Access Compliance Report

Public Rights-of-Way

(Curb Ramps)

Intersection ID: 48583	Main Street: STONEY_CREEK_LN	Cross Street: WATERLILY_LN	Location: SW
ADA ID: B489889D0EEB	Ramp Type: PerpDiag	Initial Pass/Fail: Fail	Overall Compliance: No
Severity Score: 21.25			
Codes/Mitigation Info/Possible Solution		Field Measurements/Component Compliance

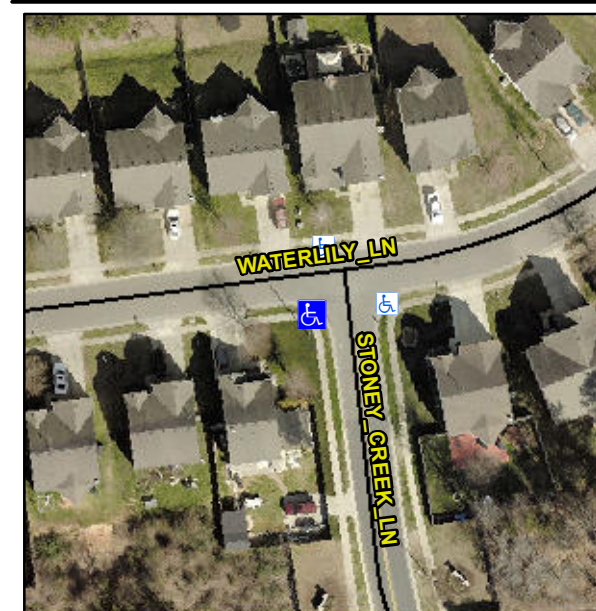
Not Found, R304.5.1, R304.2.2

Compliance	Description	Data	Compliance	Description	Data
N/A	Ramp Length (in)	47.5	No	Ramp Slope (%)	8.8
No	Ramp Width (in)	41.0	Yes	Ramp XSlope (%)	1.9
N/A	Flare Type LT	N/A	N/A	Flare Type RT	N/A
N/A	Flare Slope LT (%)	N/A	N/A	Flare Slope RT (%)	N/A
N/A	Flare Traversable LT?	N/A	N/A	Flare Traversable RT?	N/A
N/A	Landing Length (in)	N/A	N/A	DWS Provided?	N/A
N/A	Landing Width (in)	N/A	N/A	DWS Contrast?	N/A
N/A	Landing Slope (%)	N/A	N/A	DWS Length (in)	N/A
N/A	Landing X Slope (%)	N/A	N/A	DWS Full Width?	N/A
N/A	Landing Curb? (Y/N)	N/A	N/A	DWS Offset (in)	N/A
N/A	Shared Landing?	N/A			
N/A	Gutter Ponding?	N/A	N/A	Gutter Slope (%)	N/A
N/A	Gutter Lip Ht (in)	1.0	N/A	Gutter X Slope (%)	N/A
N/A	Painted X Walk1?	No	N/A	Painted X Walk2?	No
	X Walk 1 Direction	To E		X Walk 2 Direction	To N
N/A	X Walk 1 Width (in)	N/A	N/A	X Walk 2 Width (in)	N/A
	X Walk 1 Slope (%)	0.2		X Walk 2 Slope (%)	3.6
	X Walk 1 X Slope (%)	2.0		X Walk 2 X Slope (%)	0.0

Remove & Replace Curb Ramp With Two New Directional Ramps or Equivalent.
